**TOWN OF LEESBURG
NOTICE OF PUBLIC HEARING
TO CONSIDER REZONING APPLICATION
TLZM-2014-0005, PATRIOT SELF-STORAGE**

**TOWN OF LEESBURG
TOWN COUNCIL MEETING**

Subject: TLZM-2014-0005, Patriot Self Storage Park

DATE: June 12, 2015
 DRAWN BY: JS
 CHECKED BY:
 JOB NO.
 SHEET 4 OF 11

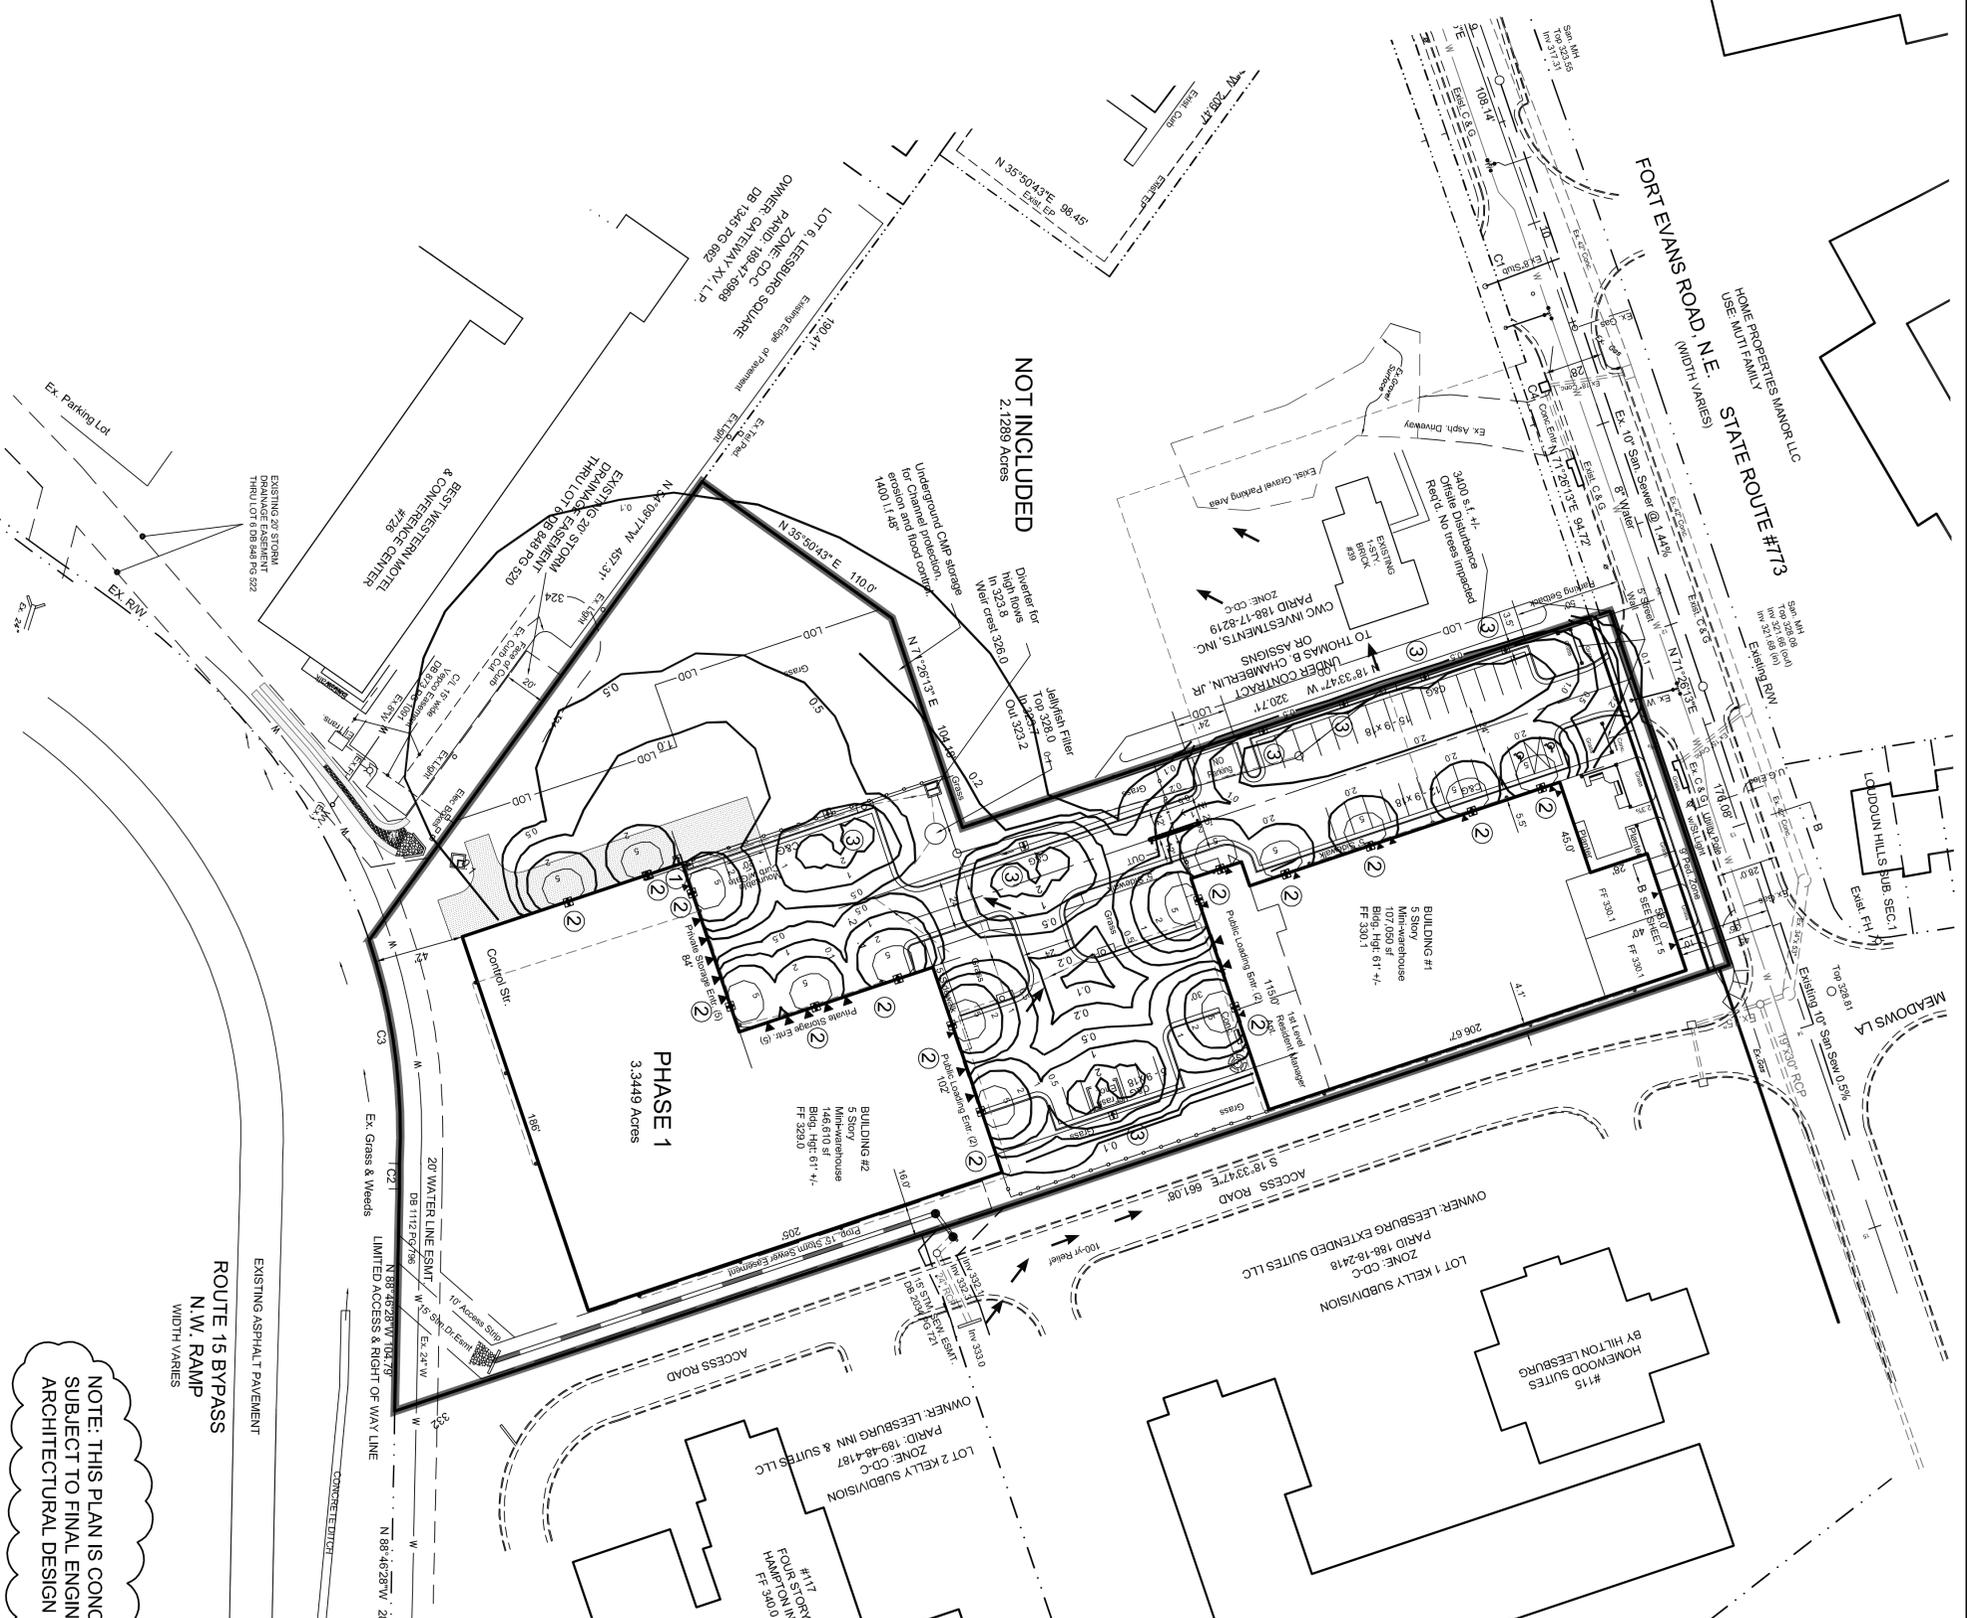
9. **Parking Lot Lighting:** It appears that the lighting contours on the Lighting Plan (Sheet 4) trespass greater than 0.5 fc (foot candles) across

BUILDING - 2
WEST ELEVATION

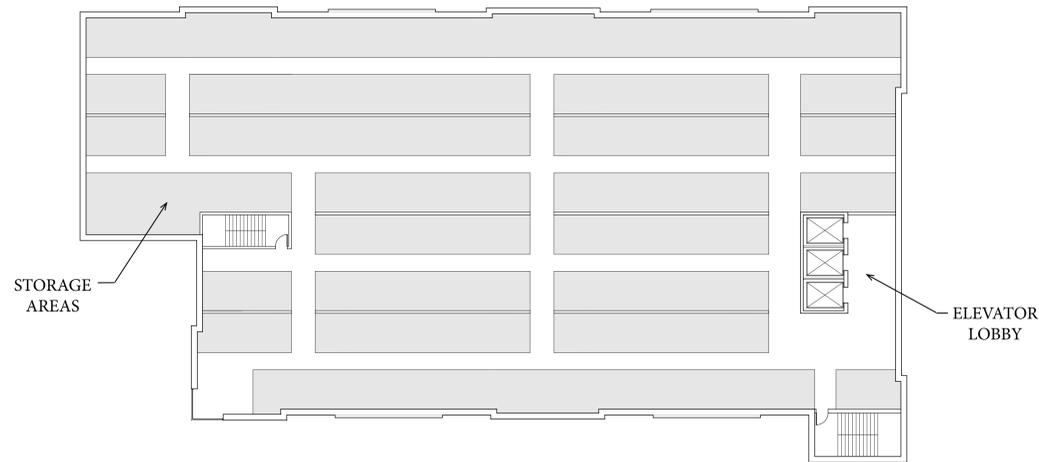
Entrance Door: Building #2, west elevation: This elevation serves as a Secondary Façade on the building and, therefore, should include at least one pedestrian entrance per TLZO Sec. 7.10.6.H.3.c. If a pedestrian entrance is not practical or feasible, then a modification must be requested.

SCHEMATIC CORNICE
DETAIL

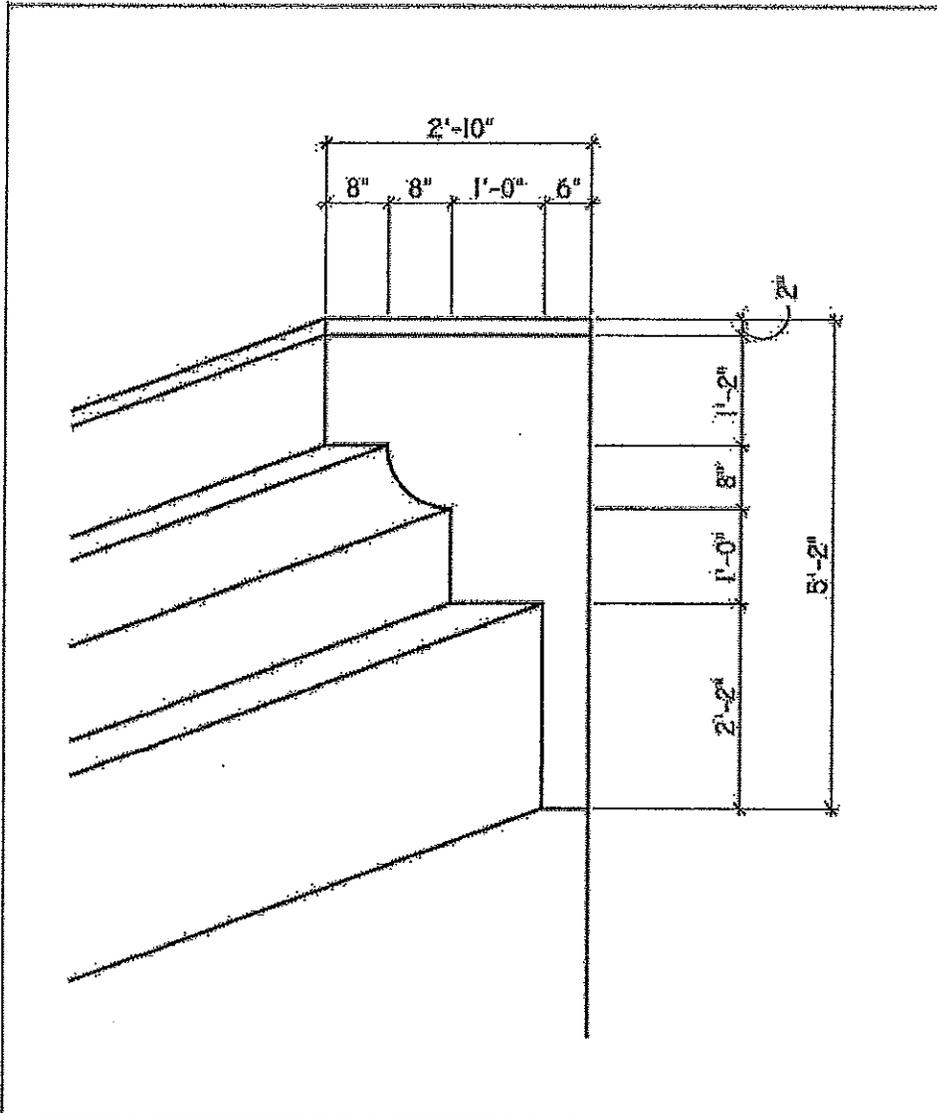
Cornice: TLZO Sec. 7.10.6.E.2 specifies that cornices should project between six and twelve inches beyond the building wall. The current two-foot ten-inch projection exceeds this range. The proposed projection may be appropriate based on the five-story height of the building, but a modification must be requested.

The Applicant requests that section 7.10.6.E.2 be modified based of the intended design of the building.

The Applicant is requesting a modification to the Zoning Ordinance on the premise that the maximum distance of 12 inches is not in keeping with the characteristics of a five-story building. The intended design is considered proportional for the structure and in keeping with the overall aesthetic of the building.
